## ACCEPTANCE TEST REPORT FOR THE SAFETY CLASS SHUTDOWN SYSTEM

Key Words: 241-A-101; Interim Stabilization; Jet Pumping; Single Shell Tanks; Safety Shutdown Circuit; Safety Class; Saltwell Pumping

Abstract: This document provides the Acceptance Test Report for the successful testing of the Safety Shutdown Circuit. The test was done in accordance with the requirements that were defined in WHC-SD-WM-SCH-003, Interim Stabilization Safety Class Trip Circuit CGI Dedication Criteria. The actual test procedure document was contained in WHC-SD-WM-ATP-185, Acceptance Test Procedure for the Safety Class Shutdown System.

FIGURE 5.1 SAFETY CLASS CONTROL CABINET A

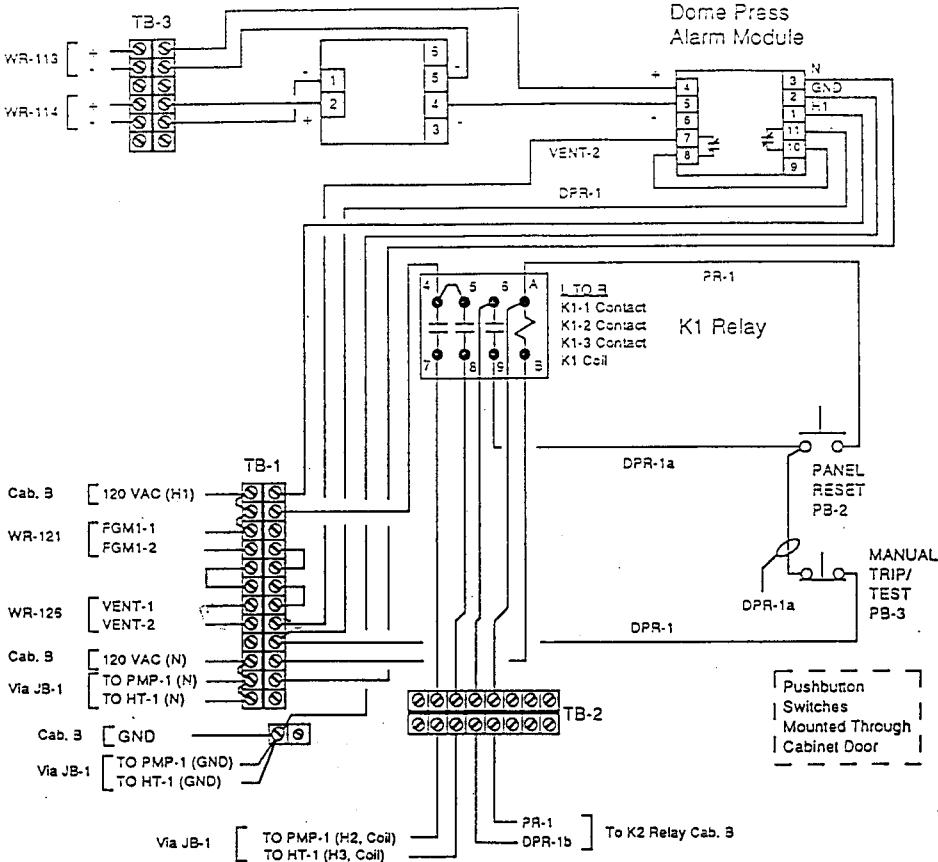
EXCEPTION # 7

ATP step number: FIGURE 5.1 p 28, FIGURE 5.2 p 29	ATP Exception Log Number: 7
<b>Description of Exception:</b> FIGURES 5.1 and 5.2 do not reflect field asbuilt conditions.	
<b>Resolution of Exception:</b>	
ECN 632835 WAS WRITTEN TO CORRECT THE ORIGINAL ECN 632817. THE CHANGE ECN HAS BEEN INSERTED IN THE OTP PACKAGE ES-96-00704/I FOR REFERENCE. EQUIPMENT CHANGES DO NOT INVALIDATE TEST RESULTS. ACCEPT TEST RESULTS AS RECORDED	
Date of Resolution:	9-19-96
Test Director signature:	<i>mhk</i>
Cognizant Engineer signature:	<i>DR. Bunn</i> 9/19/96
Quality Assurance signature:	<i>PS Ellwood</i> 9.19.96
Tank Farm Operations signature:	<i>D. J. Sweeney</i> 9/22/96

FIGURE 5.2 SAFETY CLASS CONTROL CABINET B

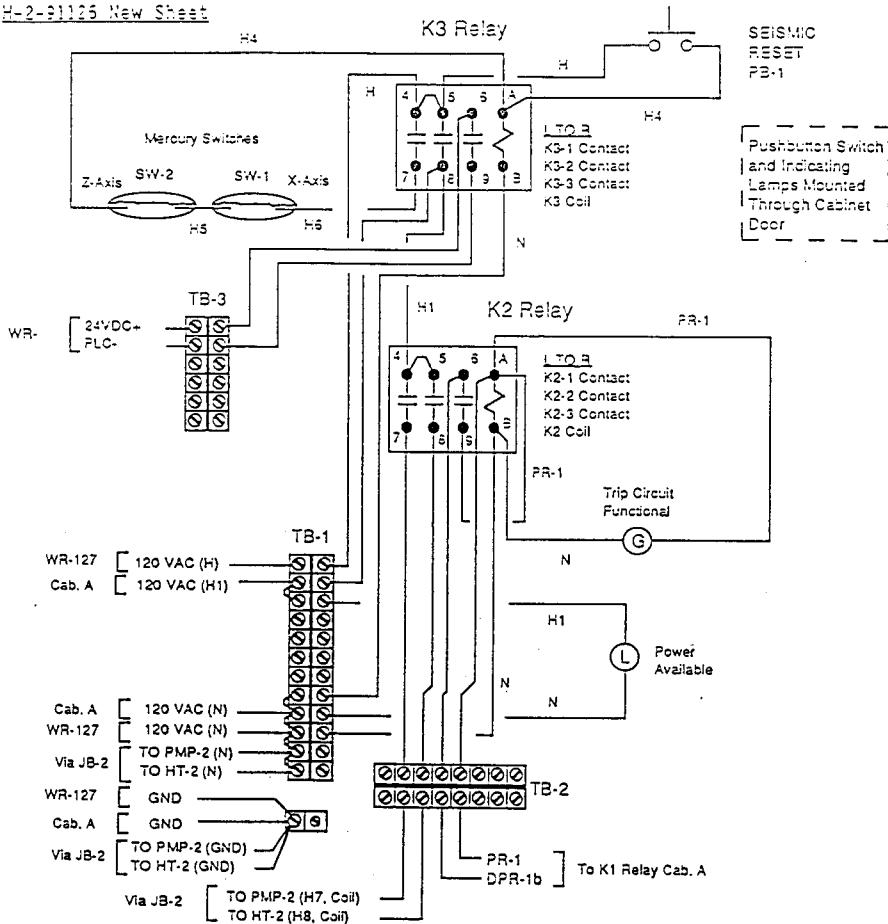
EXCEPTION #7
